Subject: Proposed License Amendment
Service Water Backup to the Reactor Equipment Cooling Post LOCA
Cooper Nuclear Station, NRC Docket 50-298, DPR-46

LICENSE AMENDMENT
SERVICE WATER SYSTEM BACKUP TO THE
REACTOR EQUIPMENT COOLING SYSTEM
IN A POST LOCA CONDITION
COOPER NUCLEAR STATION
NRC DOCKET NO. 50-298, LICENSE DPR-46

SAFETY EVALUATION
PROPOSED LICENSE AMENDMENT
SW/REC INTERTIE

SW/REC INTERTIE
NLS 990050
FIGURE 1

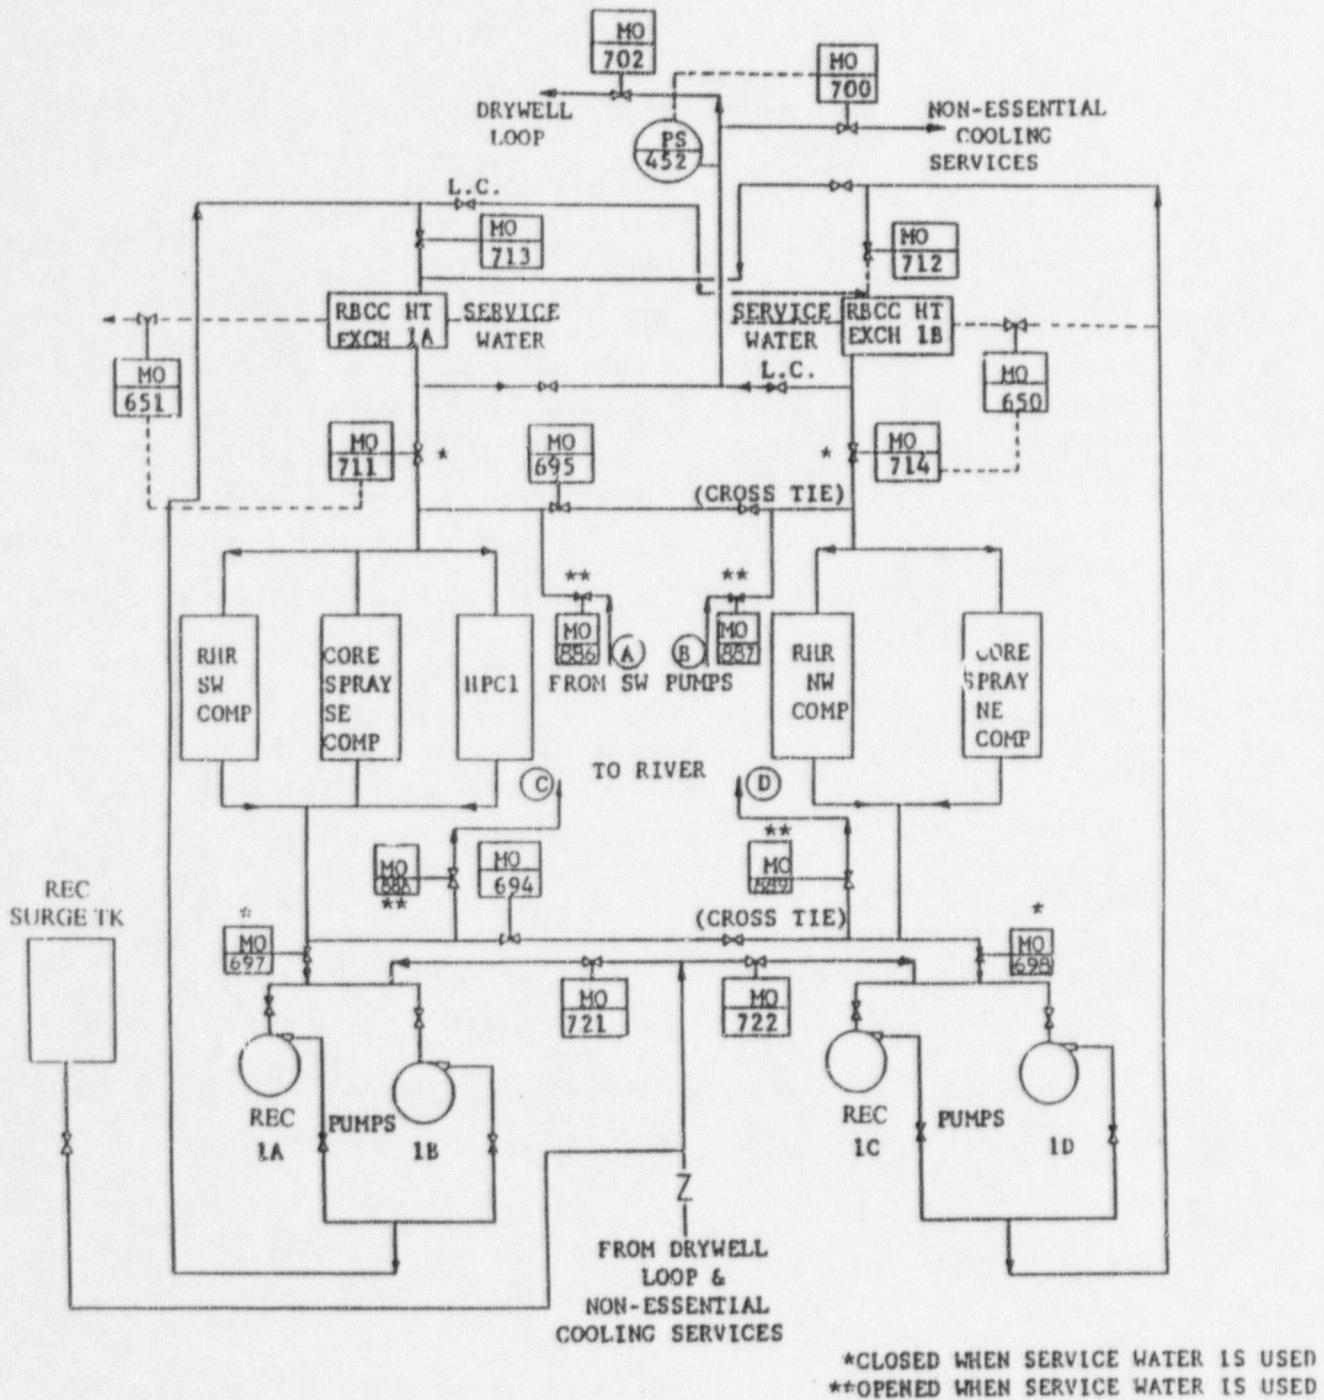
The SW and REC systems were modified, prior to initial licensing, with the provision of interties so that service water could be injected into the system to directly supply essential cooling loads (See figure 1). The above SW/REC intertie licensing basis does not include credit for use in a post LOCA condition. At the time of initial licensing, the REC safety function was credited within 5 minutes after event initiation. Service water backup is a manual operation from the Control Room for which credit cannot be assumed in the first 10 minutes following event initiation. Although not stated, and since under the then licensing basis it was not necessary, this was likely the reason that service water backup to the REC was not credited during post LOCA conditions. Trending (prior to a postulated LOCA) routinely provides the control room operator with REC system leakage information. In a post LOCA situation, this leakage information would assist the operator in taking timely action to initiate the service water back-up before the need is alarmed in the control room. A recent calculation (Reference 4) has determined that there is sufficient time for the operator to initiate the SW/REC back-up function after annunciation in the control room without impacting ECCS operation, and this information has been incorporated into the USAR.
